**Committee of Experts on the Transport of Dangerous Goods
and on the Globally Harmonized System of Classification
and Labelling of Chemicals**

**Consequential amendments to INF.8 (GHS) - INF.28 (TDG)
(Amendments for desensitized explosives)**

**Transmitted by the experts from Germany and the United States of
America¹**

Annex I

Decision logic 2.17.1 for desensitized explosives
(amendments within the decision logic are not shown)

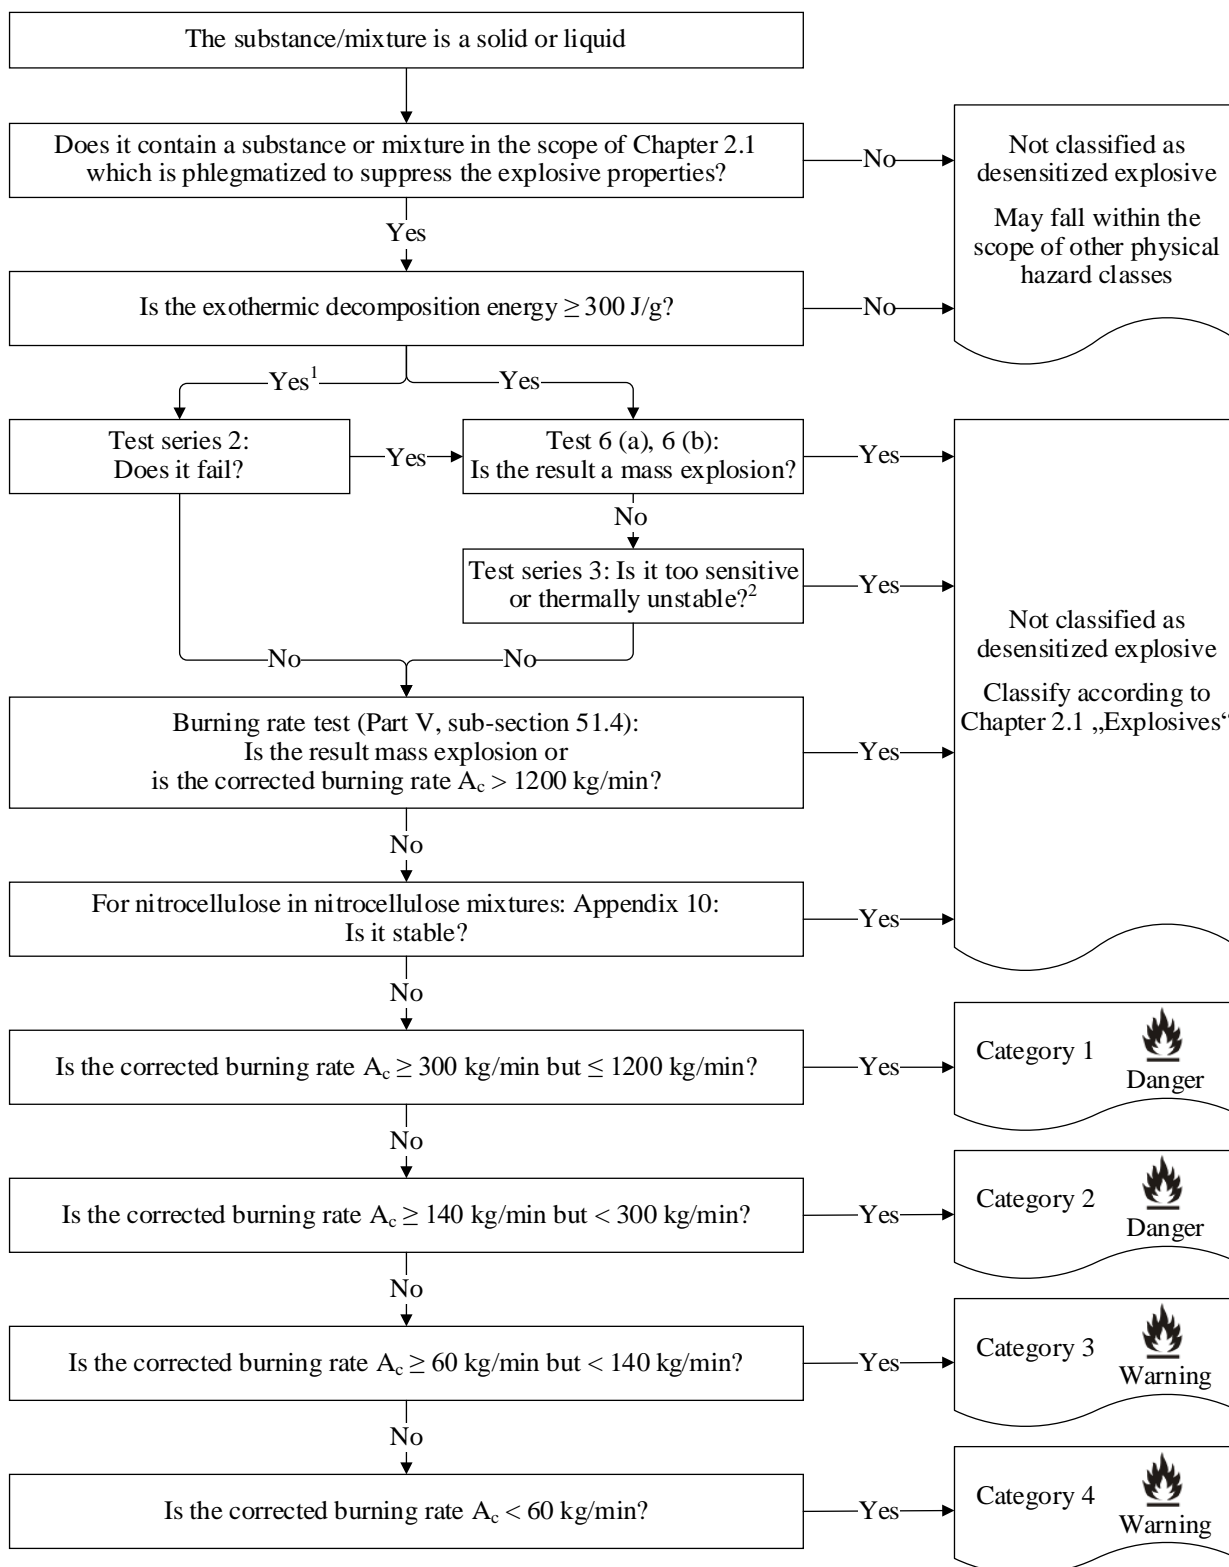
2.17.4.1 *Decision logic*

To classify desensitized explosives, data for the sensitivity, thermal stability, explosive potential and the corrected burning rate should be determined as described in Part I and Part V of the *Manual of Tests and Criteria*. For nitrocellulose in nitrocellulose mixtures, additional data for the stability as described in in Appendix 10 of the *Manual of Tests and Criteria* are needed. Classification is according to decision logic 2.17.1.

¹ Test series 2 is optional. The alternative route (via test 6 (a) and (b) and test series 3) may be taken directly without performing test series 2.

² Test series 3 is not applicable to nitrocellulose mixtures containing no other explosives than nitrocellulose.
